Subject	Eastly Alternation
Description	Enabling works to allow implementation of full runway alternation during easterly operations
Location	Heathrow Airport, Hillingdon
Reference	41573/APP/2024/2838

1. Introduction to the Review
- 1.1.

The following represents a review of the Noise impacts of the planning application for the works to enable full runway alternation when operating easterly departures.
- 1.2.

Diagram 2.2 Loss of production of wide body aircraft due to Covid (Aircraft produced by year) Source: Airbus/Boeing

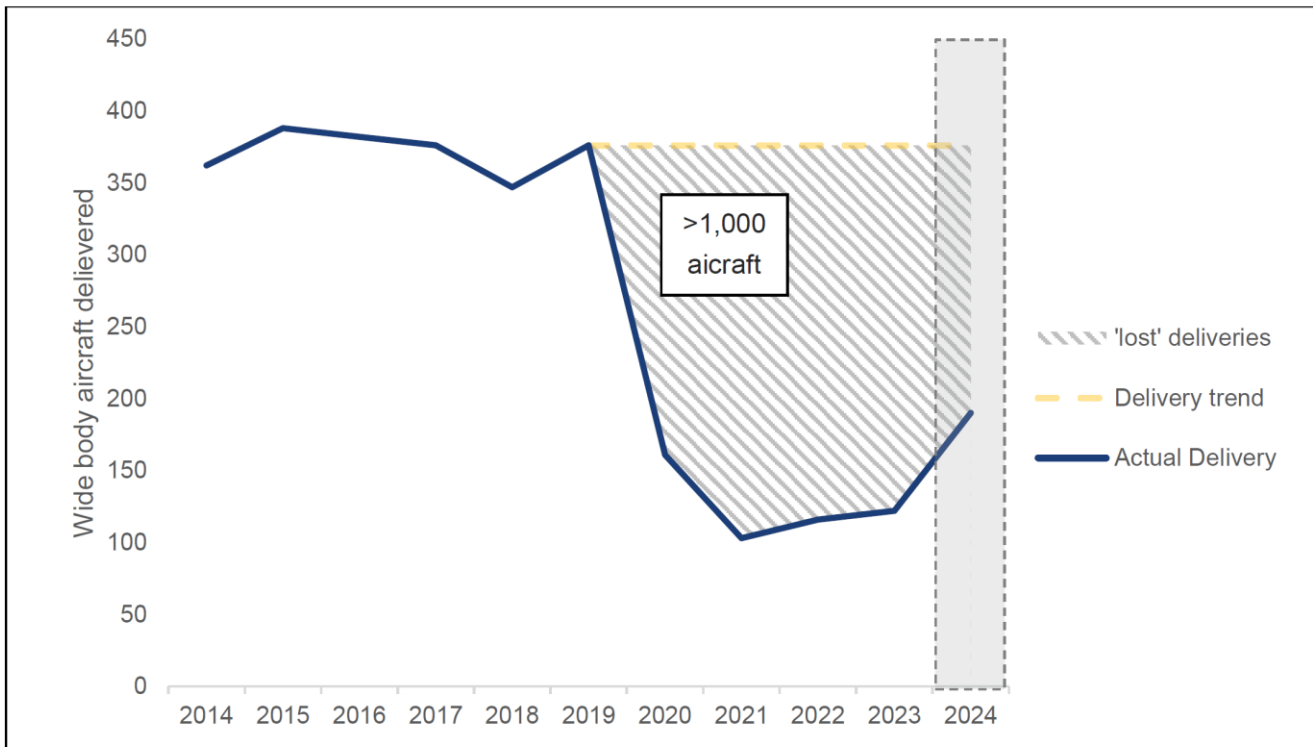
- 3.17. The matter of fleet transition was discussed at length during the recent Gatwick Development Consent Order (DCO) examination. Gatwick Airport Limited (GAL) produced an ES Addendum ([Updated Central Case - Aircraft Fleet](#)) in May 2024 which stated:

- 3.18. It included the following diagram to illustrate the impacts on the difference between expectation and reality of fleet progression:

3.19. As a consequence, the noise assessment was updated to reveal that noise contours would not reduce as much as per the original ‘central case’:

- 3.20. In relation to air noise contours, table 3.1 of the Updated Central Case shows that the 2019 baseline resulted in a 54dB Laeq 16hr contour of 74km², with the original Central Case showing a reduction to 66.8dB Laeq 16hr. However, the Updated Central Case reflecting updated assumptions regarding fleet transition identifies a more modest 71.8dB Laeq 16hr.
- 3.21. **The information provided in the Noise Chapter (Easterly Alternation) needs to be considered in light of the above. We would look to the Applicant to provide more robust evidence to support their assumptions about the future operating fleet.**
- 3.22. **Future Aircraft Ground Baseline: Given the above, commentary on the Future Aircraft Ground Baseline will need to be reviewed as they are inherently linked.**

31. Clarification around Fleet mix and transition is required with evidence to be produced to demonstrate the current assumptions are accurate.
